ADDENDUM NO. 3

DATE: April 8, 2015

Contract 14-C-00025; Howard F. Curren AWTP Junction Chamber No. 1 Conduit Repairs

SHEET
D-03

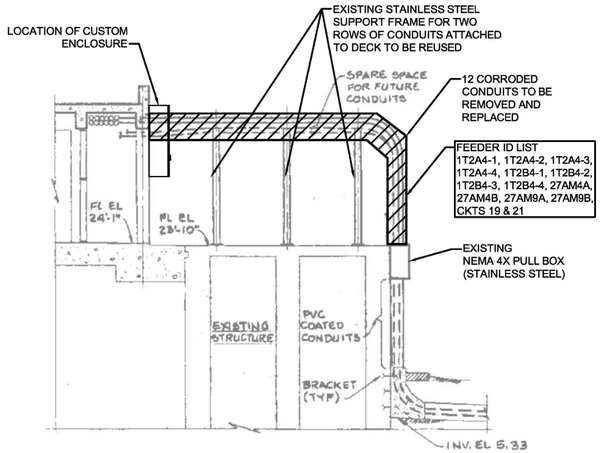
Item 3: Demolition and Electrical One-Line Diagram clarification: Sheets D-03 Demolition Details II, E-03 One-Line Diagram and supplemental drawing BE7 Junction Chamber No.1 Expansion Electrical Lighting Plan: The conductors in the 2" conduit are not for CT metering equipment, but for 2-20A/1P circuits #19 and #21, feeding light fixtures and receptacles in the transformer yard; the circuits originate at Panel LP-27Aas shown on Sheet BE7.
